Product / Process Change Notification (PCN)																															
<input type="checkbox"/> Major Change <input checked="" type="checkbox"/> Minor Change																															
PCN Number: PCN_IndLHMI_20241026 Affected Series: WE-LHMI Affected Order Codes: Please refer to table 1 PCN Date: 2024-07-26 (YYYY-MM-DD) Effective Date: 2024-10-26 (YYYY-MM-DD)	Change Category: <input type="checkbox"/> Equipment/Location <input checked="" type="checkbox"/> General Data <input type="checkbox"/> Material <input type="checkbox"/> Process <input type="checkbox"/> Product Design <input checked="" type="checkbox"/> Shipping/Packaging <input type="checkbox"/> Supplier <input type="checkbox"/> Software																														
Contact: Product Management Phone: +49 (0) 7942 - 945 5001 Fax: +49 (0) 7942 - 945 5179 E-Mail: pcn.eisos@we-online.com	Datasheet Change: <input checked="" type="checkbox"/> Yes <input type="checkbox"/> No Attachment: <input type="checkbox"/> Yes <input checked="" type="checkbox"/> No

Description of Change: Due to packaging optimizations, Würth Elektronik eiSos will change the product's packing method, and because of a database mismatch, Würth Elektronik

Table 2. Packaging Changes of affected Order Codes

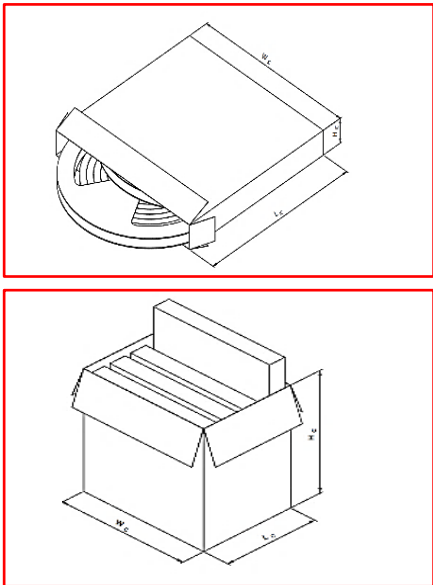
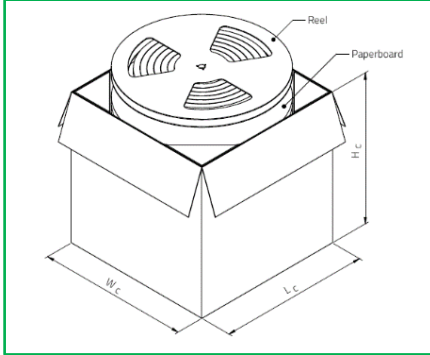
1. To reduce the amount of packaging waste in the product series WE-LHMI, with sizes and order codes indicated in table 1, the inner boxes will be omitted. No plastic filler will be used, and every reel will be stacked and separated by paperboard. The outer box dimension, reel quantity (pcs.), and box quantity (pcs.) will be updated accordingly. Additional details of the changes can be found in the table below:

Packaging specifications for size 4020HT (Table 1 section a)	L _c (mm)	252,00	L _c (mm)	360,00
	W _c (mm)	348,00	W _c (mm)	360,00
	H _c (mm)	354,00	H _c (mm)	270,00
	Reel Qty.(pcs.)	3000	Reel Qty.(pcs.)	2000
	Reel Qty.	8	Reel Qty.	12
	Outer Box Qty.(pcs.)	24000	Outer Box Qty.(pcs.)	24000
	Packaging specifications for size 5020HT (Table 1 section b)	L _c (mm)	252,00	L _c (mm)
W _c (mm)		348,00	W _c (mm)	360,00
H _c (mm)		354,00	H _c (mm)	270,00
Reel Qty.(pcs.)		3000	Reel Qty.(pcs.)	2000
Reel Qty.		8	Reel Qty.	12
Outer Box Qty.(pcs.)		24000	Outer Box Qty.(pcs.)	24000
Packaging specifications for size 7030HT (Table 1 section c)		L _c (mm)	252,00	L _c (mm)
	W _c (mm)	348,00	W _c (mm)	360,00
	H _c (mm)	354,00	H _c (mm)	240,00
	Reel Qty.(pcs.)	1000	Reel Qty.(pcs.)	1000
	Reel Qty.	8	Reel Qty.	9
	Outer Box Qty.(pcs.)	8000	Outer Box Qty.(pcs.)	9000
	Packaging specifications for size 7050HT (Table 1 section d)	L _c (mm)	252,00	L _c (mm)

W _c (mm)		348,00	W _c (mm)	360,00
H _c (mm)		354,00	H _c (mm)	240,00
Reel Qty.(pcs.)		800	Reel Qty.(pcs.)	800
Reel Qty.		8	Reel Qty.	9
Outer Box Qty.(pcs.)		6400	Outer Box Qty.(pcs.)	7200
